**INFORMAL REFERRAL COMMENTS – DA 090/E024/21  
7-21 VICTORIA STREET GOODWOOD**

*Demolition of existing, vacant single-storey nursing home and construction of a two (2) storey, 100-bed nursing home with associated fencing, car-parking and landscaping.*

SITES ≤ 300m<sup>2</sup> for BUILDING ABOVE 2s (7m)  
SIDE SETBACK 3m + 1/2 OF ADDITIONAL HEIGHT

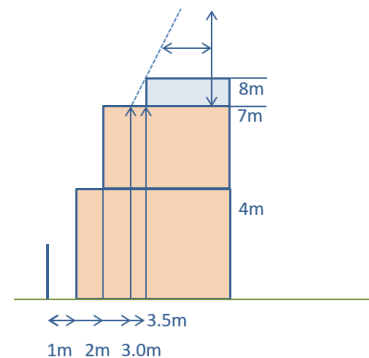
- Proposed building has generous eastern side setback, even relative to large 8 metre scale, of 6.1 metres and exceeding typical boundary setback policy of 3.5 metres for such building height;
- Proposed building western side setback is over 20 metres and affords a well landscaped open area;
- Proposed rear boundary setback building proportions are well-articulated, limited and varied across the large site width with projecting portions of approximately 16 metres wide by 8 metres high with two central ones being setback 6.1 metres and other west and east portions setback 6.8 and 7.2 metres. Generally, reflects typical boundary setback policy of 7 metres for 8 metres height;

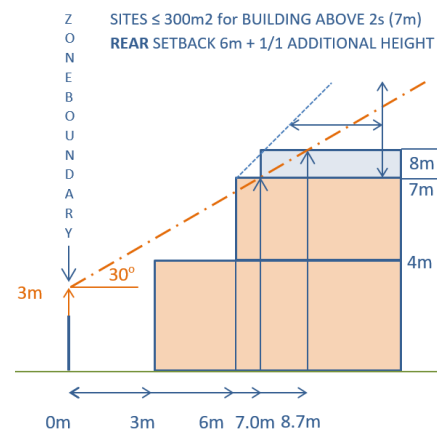
- Policy for buildings of '3 storeys or more (or heights greater than 7 metres)' also provides for a building envelope of a 30 degree plane, measured from a height of 3 metres above ground level at the zone boundary (rear site boundary in this case). This indicates 8.7 metres for 8 metres height, which has not been provided. A greater setback would be desirable but the limited portions across the overall site width mitigate the overall implications of variation;

#### **Footpath Canopies**

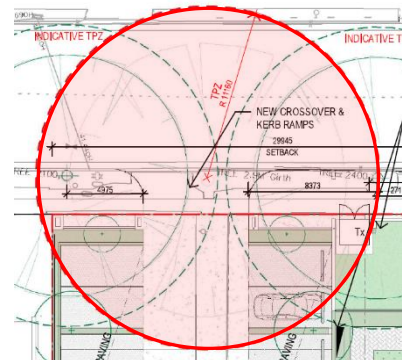
There are no encroachments of the public realm.

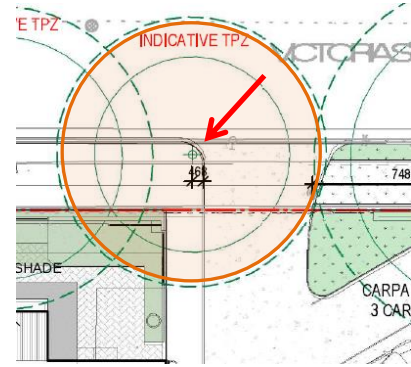
Proposed central drop-off area western crossover appears to provide inadequate clearance and conflict with an existing street tree, which is unwarranted and should be addressed to avoid likely damage/loss of a substantial street tree.

Proposed eastern narrowed crossover (3.4 metres) appears to provide good clearance to existing street tree (1.2 metres) for limited vehicle parking on-site, and service access to east and rear of site. The direct access for service and two car spaces on-site and consequential loss of on-street parking is queried.

Similarly, the western end double on-site space and crossover appear to provide little gain for disruption to on-street parking. There seems no nett gain and likely loss of space and flexibility of overall parking.
